UNITED STATES PATENT AND TRADEMARK OFFICE

APPLICATION NO.	FILING DATE	FIRST NAMED INVENTOR	ATTORNEY DOCKET NO.	CONFIRMATION NO.
10/823,226	04/12/2004	Manfred Hermann	TER-P030541	4625

Office Action Summary

DETAILED ACTION***Claim Rejections - 35 USC § 102***

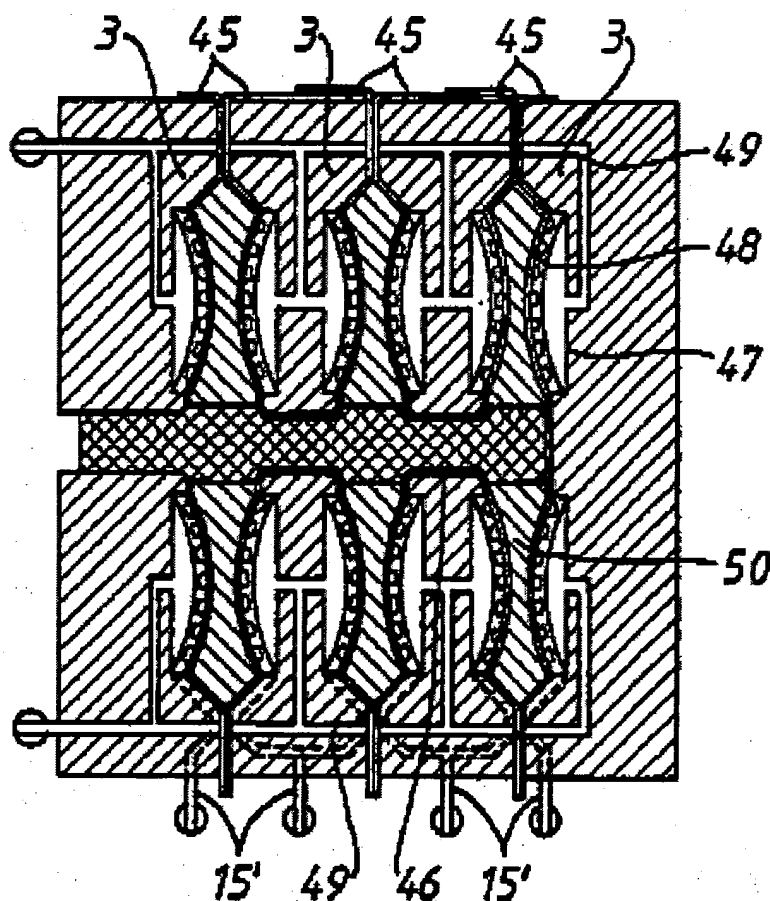
2. Claims 1-2 and 13-14 are rejected under 35 U.S.C. 102(b) as being anticipated by Davis (U.S. 4,911,839). Davis discloses a membrane 14 having a membrane surface without

perforations and including a plurality of bosses 15 as supporting elements. A membrane margin 14b encloses the membrane on a radially outer surface thereof and an inner margin 14c encloses an inner margin thereof. The membrane also includes a planar portion 14f without supporting elements supported by a stay boss 17 (col. 4, lines 18-21) [as in claims 1-2]. Davis also discloses a membrane plate having a plate margin including a peripheral groove 11b for retaining therein a peripheral bead of the membrane (the end of 14b) [as in claim 13]. As shown in figure 1, mirror portions are found on either side of a longitudinal axis extending from the top to the bottom of the figure and passing through 16 [as in claim 14]. It is pointed out that neither the

membrane of claim 1 nor the membrane/plate of claim 13 is in combination with the sludge inflow that is present when in a final mounting state. Such is an intended use of these subcombinations that fails to further limit the structures thereof.
